IEEE P802.11
Wireless Access Method and Physical Layer Specifications

Title: Detailed Draft Standard text changes to support DTBS.

5.2.5 Priority resolution phase

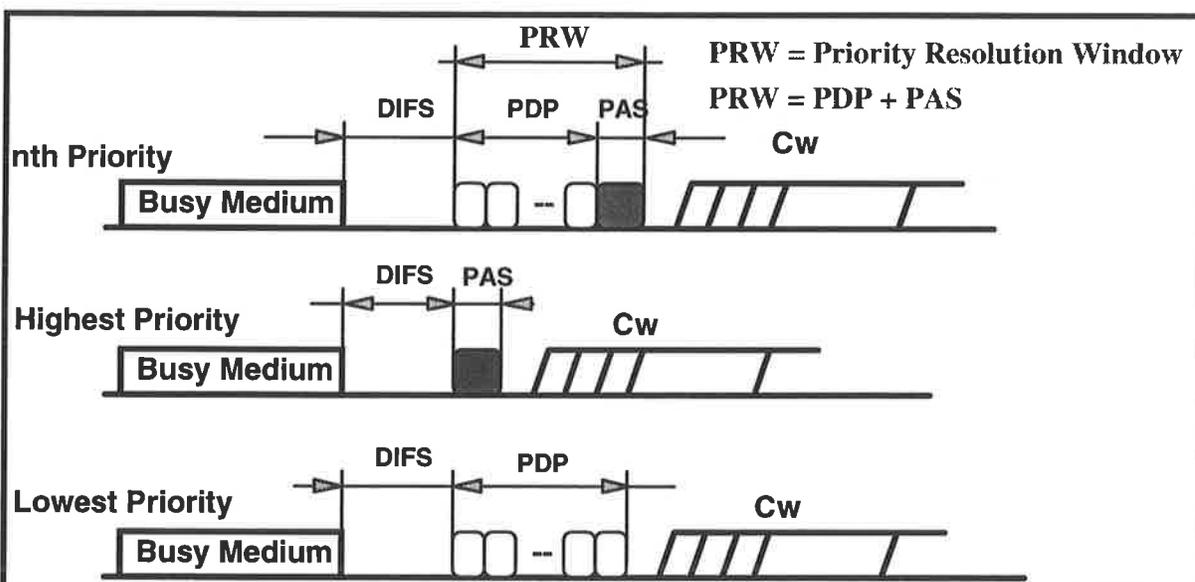
The Priority resolution phase is designed to distinguish access between different priority levels, such that the subsequent Contention Resolution Phase will resolve contention between traffic of equal access priority. The MAC State Machine supports two different mechanisms by specifying two different access parameters.

The Priority resolution window (PRW) consists of a "Priority Detection Period" (PDP), and a Priority Assertion Signal period (PAS). Either of the two periods can be specified as zero.

The following procedure will be used to resolve priority resolution:

If during the PDP period the medium is detected Busy (by using the available carrier sensing mechanism), then a station shall defer until DIFS after the next frame to compete for the medium again. The PDP period can also be zero.

After the PDP period, a station shall generate Ph-DATA.request (SEND PAS) signal to the Phy to generate the PAS. This will turn on the transmitter to send the normal Phy preamble for the duration of a PAS interval.

This is to signal its priority level to the other stations contending for the medium. The PAS interval can also be specified zero, which will cause that no Ph-DATA.request (SEND PAS) will be generated by the MAC.

Modifications to the Control State Machine.

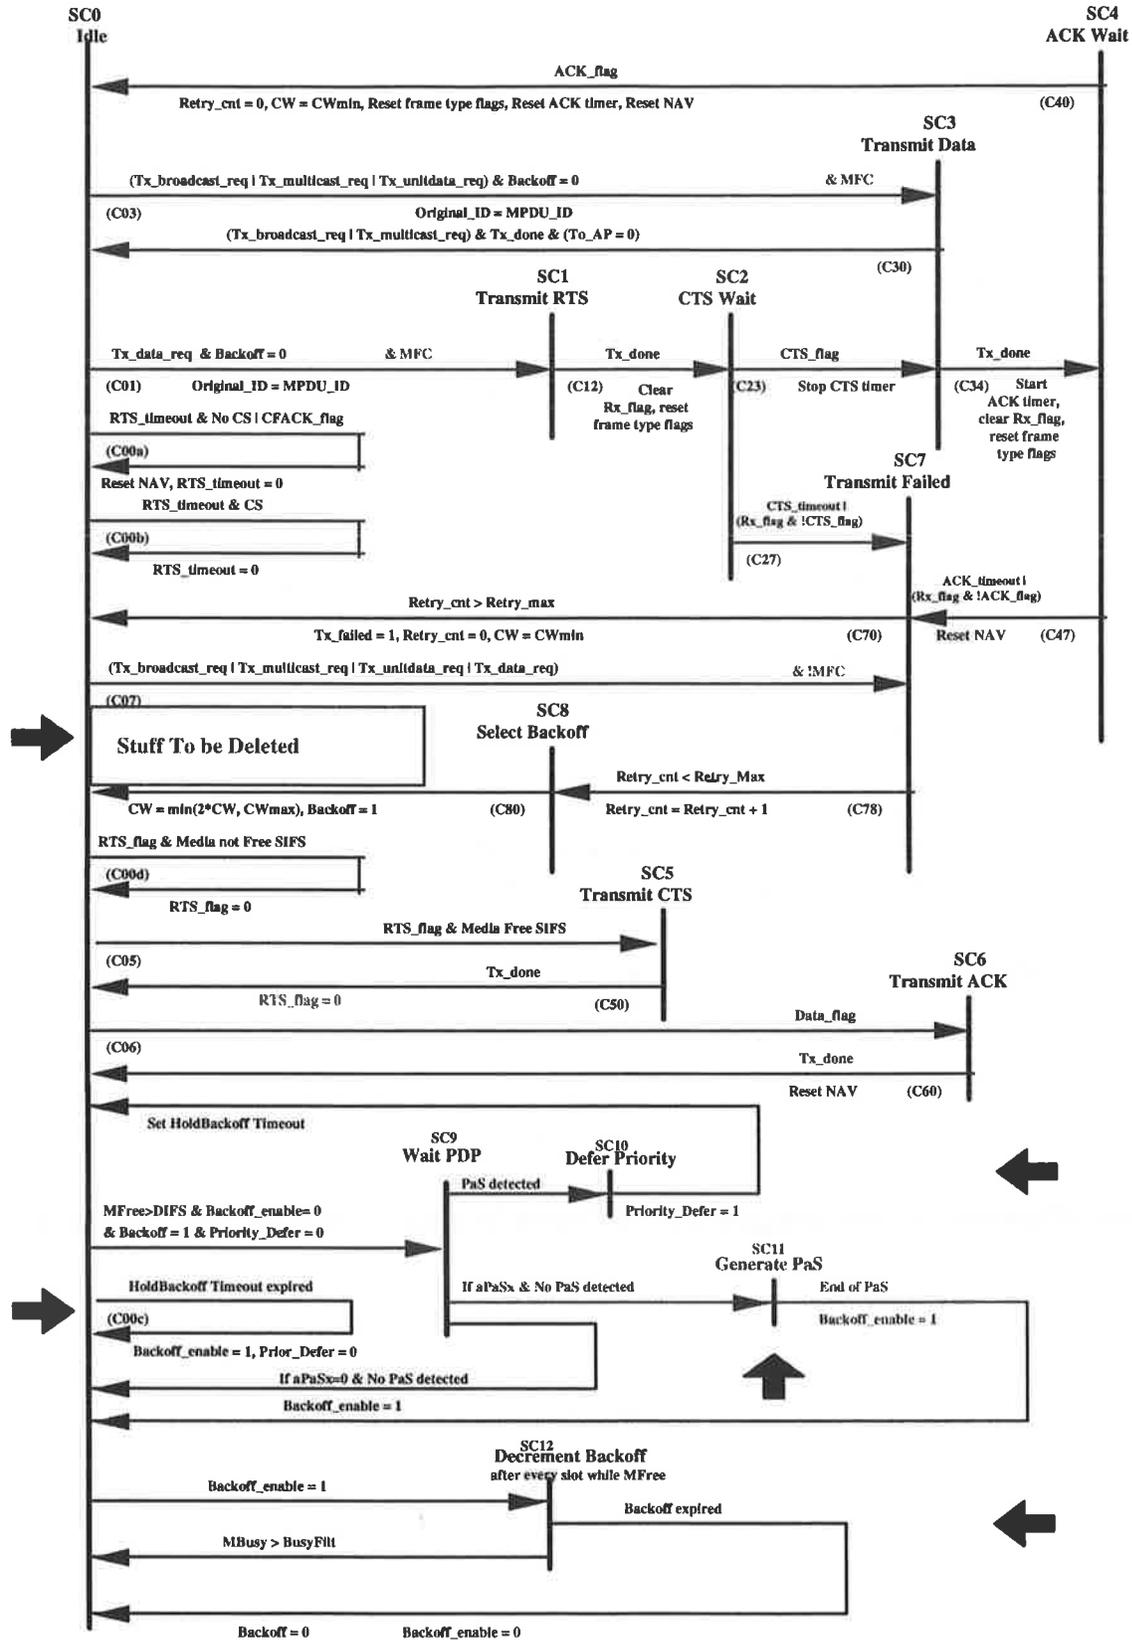
The following changes are needed in the Control State Machine:

Currently there is an annotation problem because the states have the same identification numbers as the state transitions. I therefore suggest to add an "S" prefix to the state-ID's. So all "State XY" names should change to "State SXY". This is illustrated in the "Modified Control State Machine" diagram.

Text changes needed in current Control State Machine notes:

- Change "media free longer than DIFS" into "media free longer than MFC" in the C01, C03, and C07 transitions.
- **State SC9, Wait PDP:** In this state the medium will be monitored for the duration of PDP to detect a PAS signal from other stations, by monitoring the !CCA. Note that the duration of PDP can be set to zero, which will then yield in a No PaS detected exit.

- **C09, Start priority resolution:** This transition will be taken when the medium has been free for DIFS after a defer (Backoff = 1), and Backoff enable = 0. This is the condition to start priority resolution.

- **State SC10, Defer Priority:** This state shall be entered when a PaS (active priority signalling) is detected, so that the station should defer for higher priority traffic.

- **C910, PaS Detected:** This transition is taken when in state SC9 an active medium has been detected via the CCA indication.
- **C100, Set HoldBackoff Timeout:** This transition shall be taken after the HoldBackoff Timer has been initialized. Also the Prior_Defer flag will be set.

- **State SC11, Generate PaS:** This is the state where the PaS signal will be generated by turning the transmitter on for the duration of the PaS interval. Note that the duration of the PaS interval can also be zero, so that no PaS signal is generated, and the state machine will fall through immediately. This state and any associated transition is optional, and does not need to be implemented by stations that do not support DTBS services.

- **C911, If PaS & No PaS Detected:** This transition is taken, when a PaS has been specified, and when during the PDP Wait period, no PaS has been detected, so when there was no medium activity.

- **C90, If aPaSx=0 & No PaS Detected:** This transition is taken when no PaS is detected and the PaS parameter is specified to be zero, so that no subsequent PaS signal will be generated.

- **C110, End of PaS:** This transition will be taken when the PaS period has elapsed, after which the Backoff_enable flag will be set, to start the contention resolution phase.

- **C00c, Enable Backoff:** This transition shall be taken when the Hold Backoff timer expires. The Backoff_enable flag shall be set to allow participation in the contention resolution process. The Prior_Defer flag will be reset.

- **State SC12, Decrement Backoff:** This is the state during which the Backoff timer is decremented after every slot interval, while the medium is free as indicated by the CCA or the NAV.

- **C012, Start Backoff:** This transition will be taken whenever the Backoff_enable is set.
- **C120a, Backoff expire:** This transition will be taken when the Backoff Timer has expired (counter reach zero). The Backoff and Backoff_enable flags shall be reset.

- **C120b, Busy detected:** This transition will be taken whenever a MBusy condition is detected with a duration that is longer then the PaSDur parameter. The Backoff_enable flag will be reset, to force a new priority resolution cycle before the backoff process will proceed, so before SC12 is entered again.
